**SAND CREEK RESTORATION**

**GENERAL NOTES**

SHEET 2 OF 99

**GRouted STEPPED BOULDER DROP #6 DETAIL  
PLAN VIEW**  
SCALE: 1"=20'

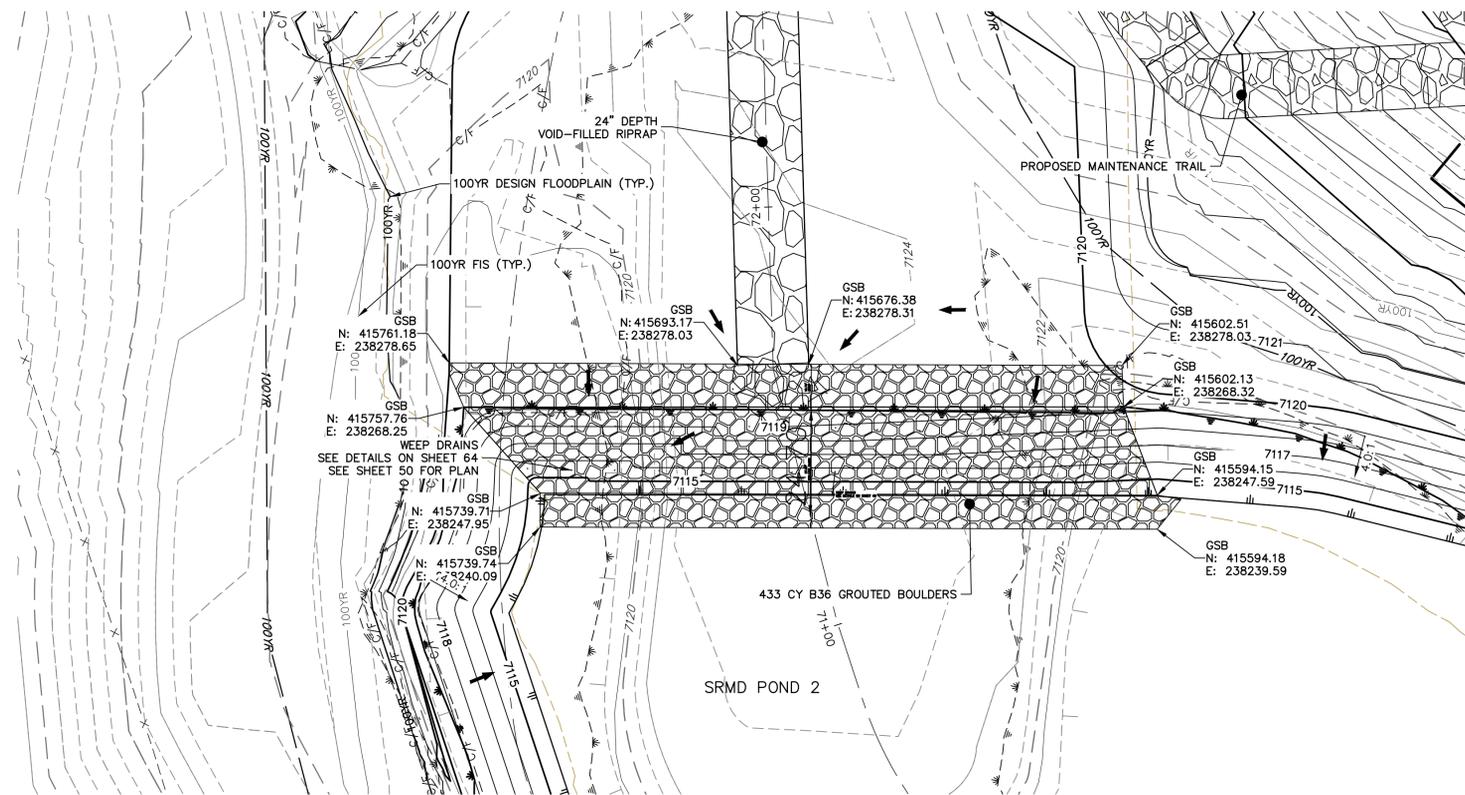
Show sheet pile

**SHEET PILE 7 PROFILE  
STA -2+00.00 TO 1+82.67**

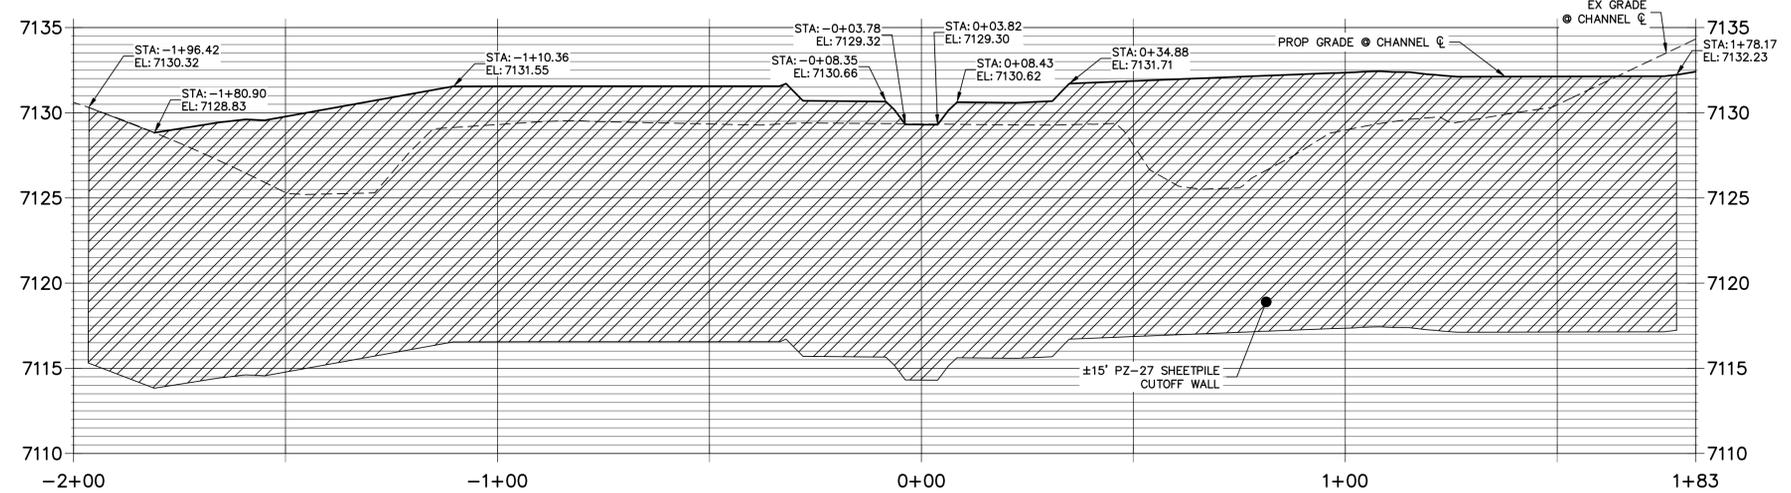
Verify depth

**SHEET PILE 8 PROFILE  
STA -0+08.44 TO 3+55.43**

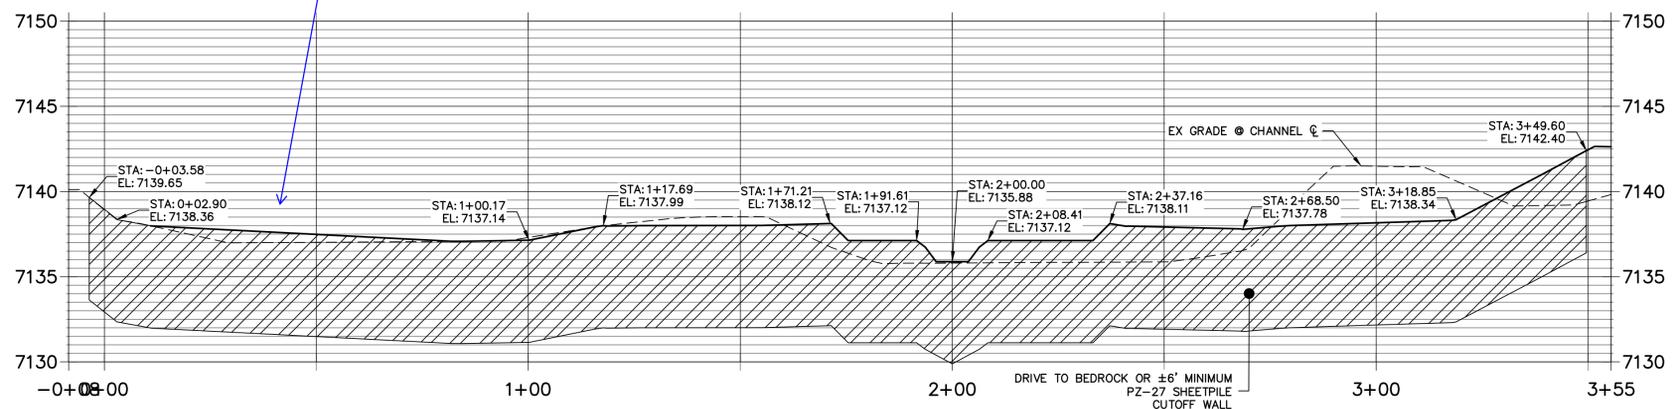
Verify depth per profile comments.

Please show 100-year WS on all 8 cross-sections

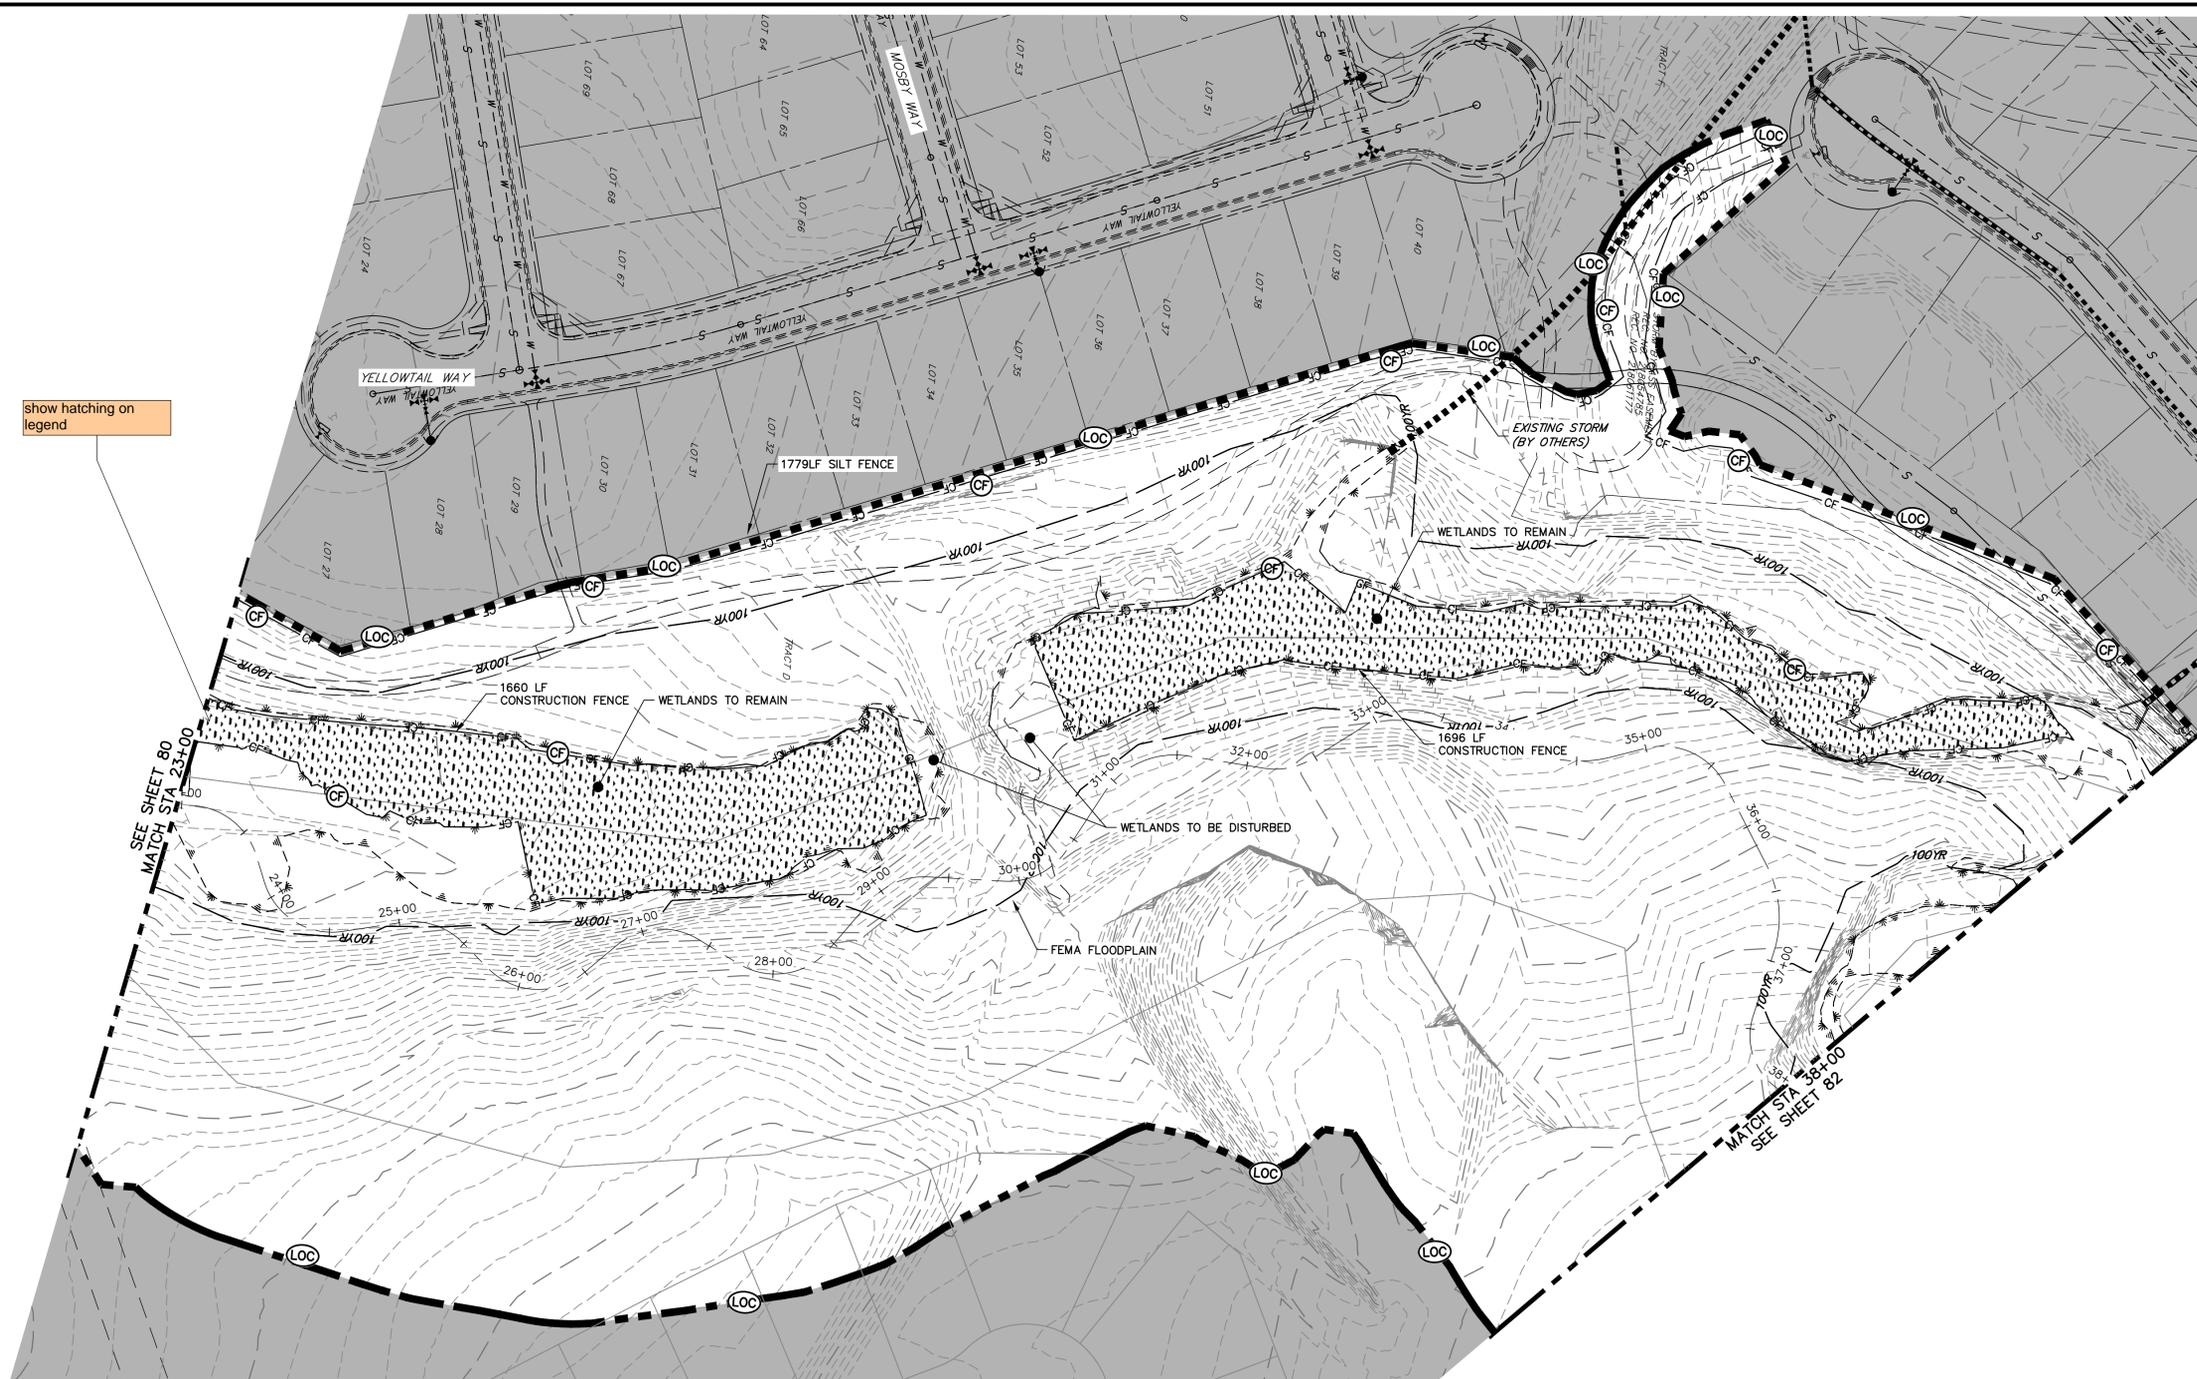
show hatching on legend
